Transposition of EED Articles 14(5)-(8)

MPA Response to the Consultation on the Transposition in England and Wales of Articles 14(5)-(8) of the Energy Efficiency Directive (EED) (2012/27/EU)

SUPPLEMENTARY NOTE submitted 2nd April 2014

MPA Response submitted 21st March 2014

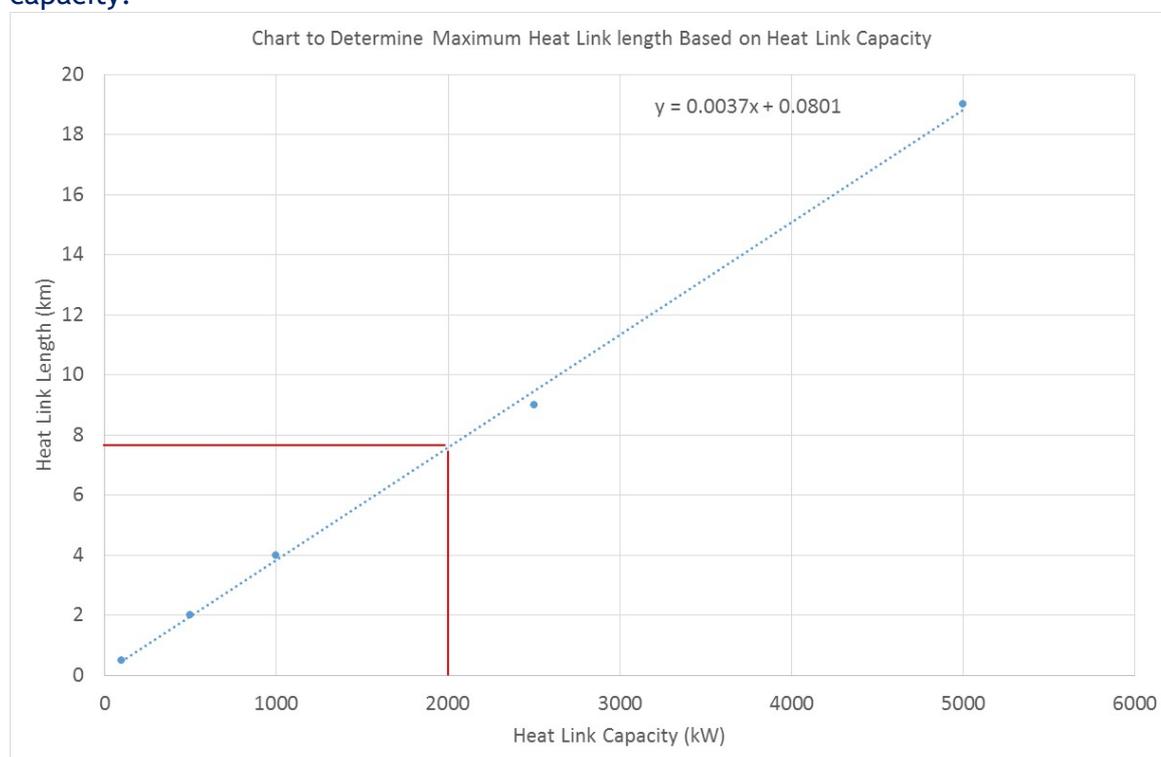
The proposed thresholds would be better presented as a chart (example chart provided below) rather than broad boundaries. For example, the maximum search radius for water as the heat transfer medium for >100kW and ≤500kW is given as 2km. However, Figure 7 in the Ricardo-AEA paper² shows that for 100kW the net present value is 0 at 400m and at 2km the NPV is negative, which means a distance of 2km is clearly not viable at this capacity. Likewise at 2000kW the chart indicates the maximum radius is closer to 7 or 8 km rather than the 9km quoted. A chart would enable the maximum radius to be more accurately determined for each specific heat capacity.

Relationship between efficiency of waste gas heat recovery and exhaust gas temperature.

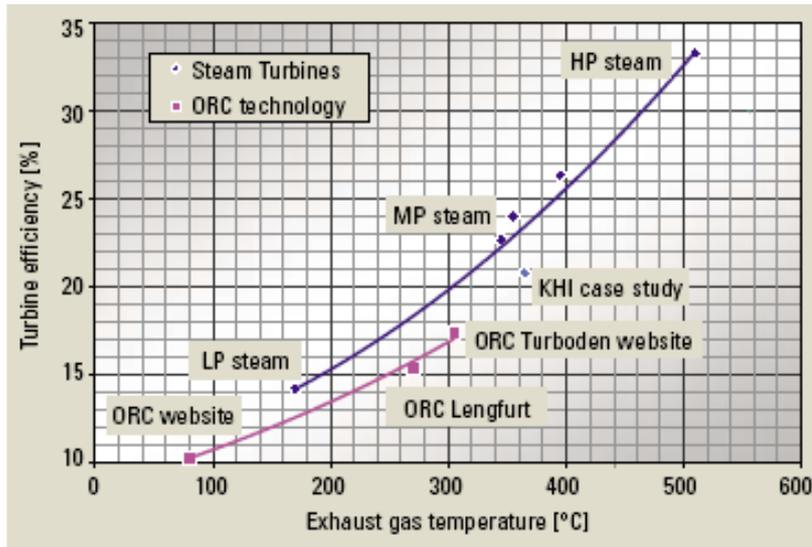
Given that UK kilns are smaller and operate at a lower exhaust gas temperature the expected power output will be significantly lower, estimated to be around 600kW. The figure below illustrates the declining efficiency of waste gas heat recovery systems with declining exhaust gas temperature.
